10. Topology discovery and protection

Editors' Notes: *To be removed prior to final publication.*

Draft 2.7, October 2003

Topics for discussion:

Figure 10.31—Span failure and recovery

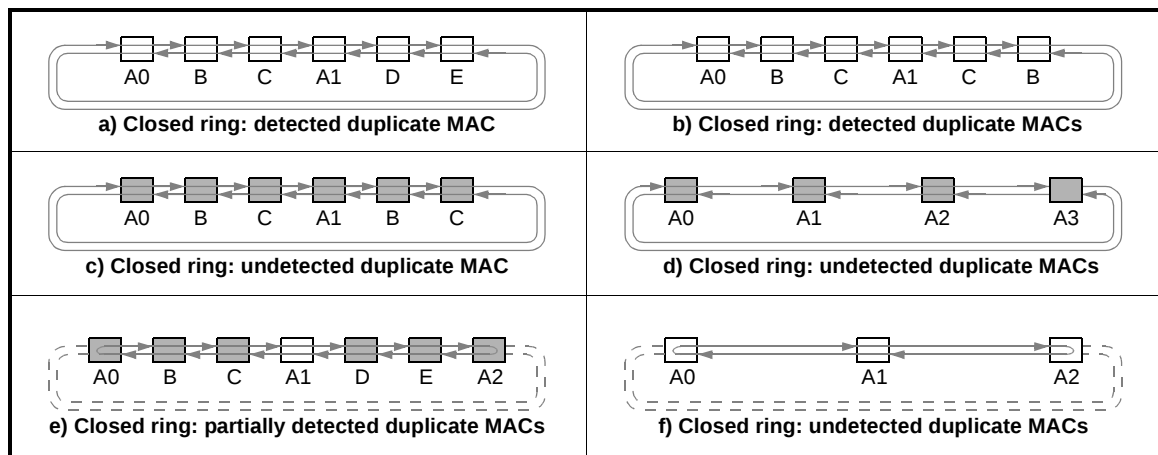
The following statement appears to be wrong: isn't it only A1 that can detect this duplicate?

b) $A0=B=C=D=A1=E=F=G=A2$ (detectable by A0 and A2)
